CITY OF CLAREMONT

September 1, 2020

RE: **Comments On “La Puerta” Application**

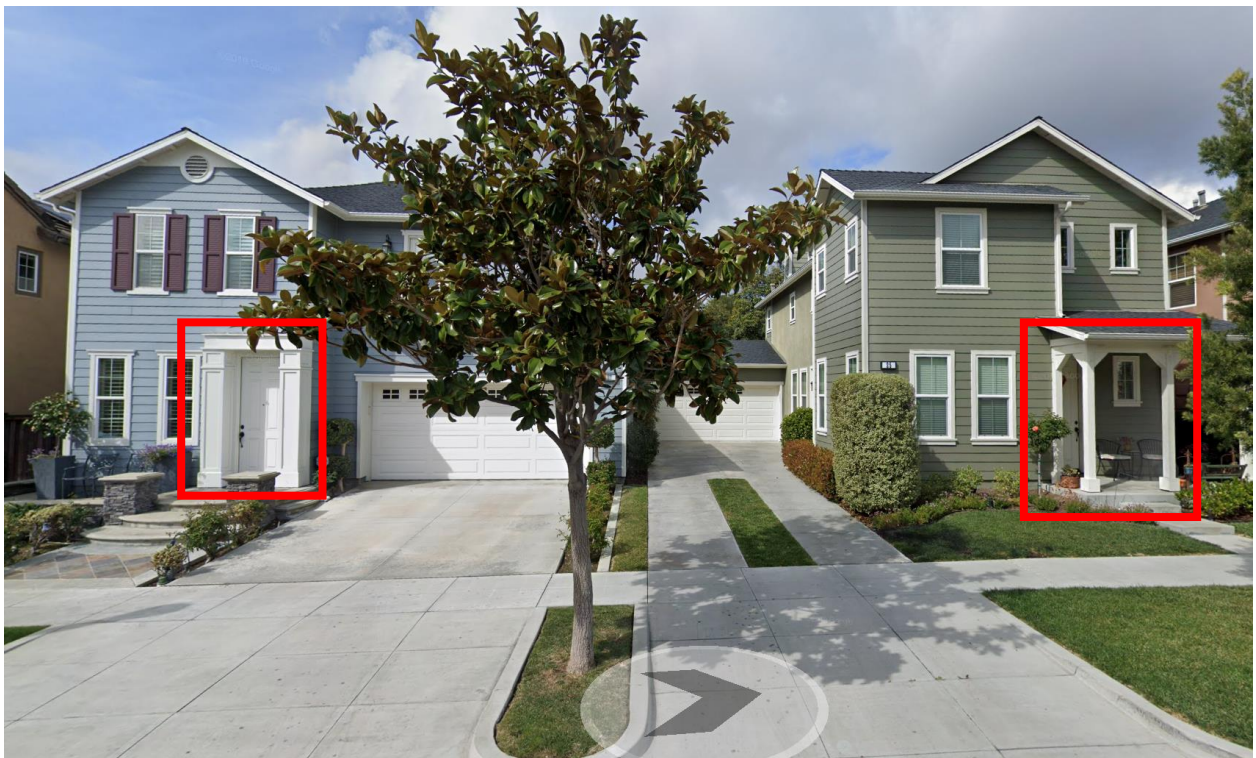
- Generally, the architecture lacks the detail and quality that is expected of projects in Claremont. Four-sided architecture treatment is expected.
- Compared to similar Trumark projects in Orange County, the homes proposed at La Puerta have less detail and architectural interest. The homes in Orange County have more detailing, including:
 - Recessed windows and doors, and windows with higher levels of trim and/or arched openings.
 - Pot shelves, wrought iron details, and other architectural details.

- See the photos below, which highlight features of the Orange County homes that are not shown in the proposed La Puerta architecture.

Ladera Ranch homes—Overlapping buildings

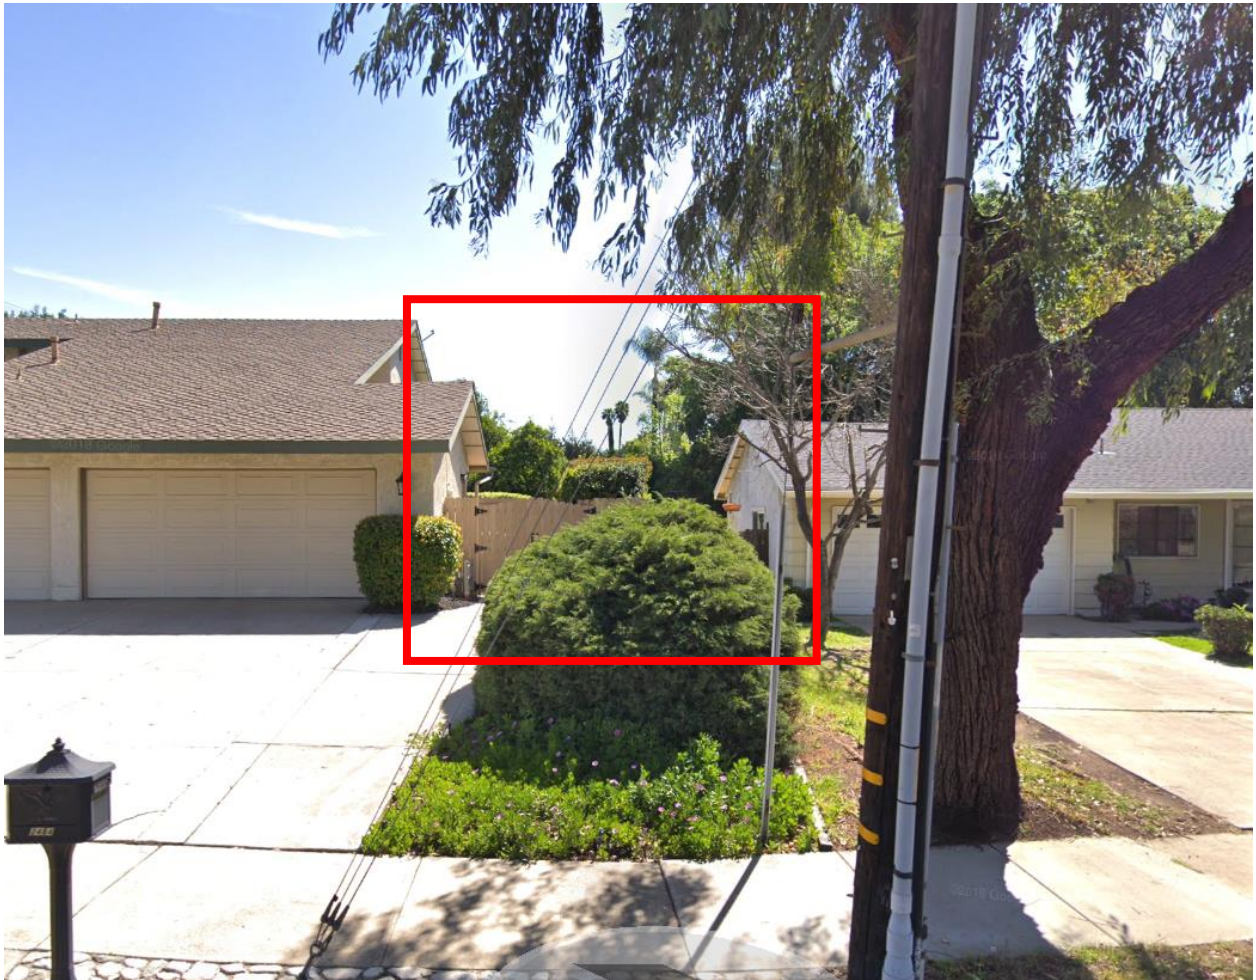
- One outcome of the “Z-lot” configuration proposed for the subdivision is the lack of sightlines between the units. The garage at the rear of the units on the Z lots overlaps with the front of the home on the other, creating a continuous façade of buildings. Compare the appearance of the streets in your Orange County projects with the appearance of the homes on Forbes Avenue:

Forbes Avenue—Space between homes

Staff suggest that you propose a different design that creates a more traditional appearance for the streetscapes within the project, with better separation and the creation of clear space (similar to the more traditional streetscape shown above) between homes.
